3Foxes Biodiversity Solutions
 23 De Villiers Road
 Kommetjie
 7975
 15 May 2021

RE: Highlands North Wind Energy Facility (WEF) Amendment Application

Figure 1. The sensitivity map for the Highlands North WEF showing the original layout left and the proposed amended layout right.

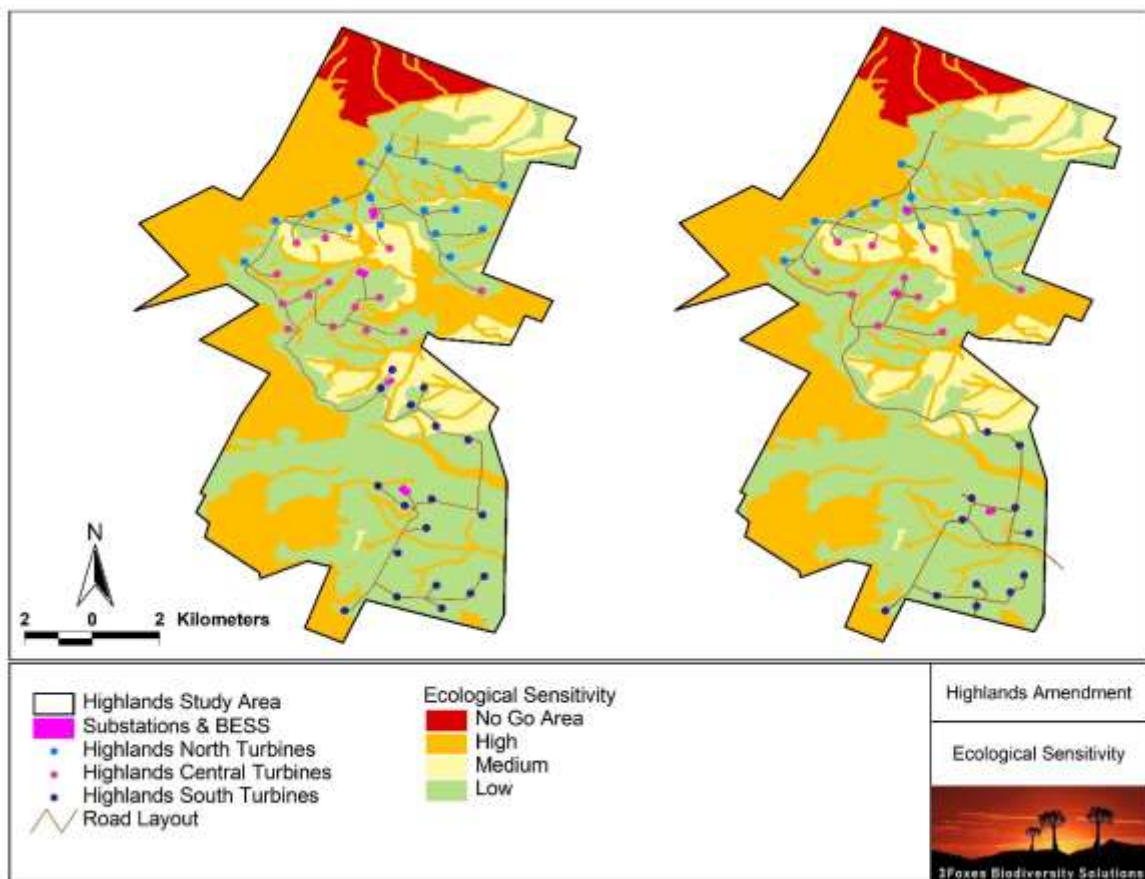
The sensitivity map for the Highlands North WEF, showing the original assessed layout and the revised proposed amended layout is illustrated below in Figure 1. The distribution of turbines and associated infrastructure in relation to the sensitive features of the site are little changed between the original assessment and the amendment. As a result, there do not appear to be any significant advantages or disadvantages of the proposed amendments, including the amended layout.

The proposed amended layout of the Highlands North WEF is located in similar areas to the original footprint and there are no turbines in High or Very High sensitivity areas under either the original or amended layout. In addition, there are no new or additional impacts associated with the proposed amendments, including amended layout, with the result that there are no recommended changes to the mitigation and avoidance measures that were included in the original Fauna and Flora specialist BA study. In addition, the cumulative impacts associated with the amendment are considered to be similar to those as assessed in the BA and thus there would be no changes to the overall cumulative impacts associated with the change. All of the mitigation and avoidance measures as recommended in the Fauna and Flora specialist BA are upheld by the current study and should be applicable to the amended layout as well.
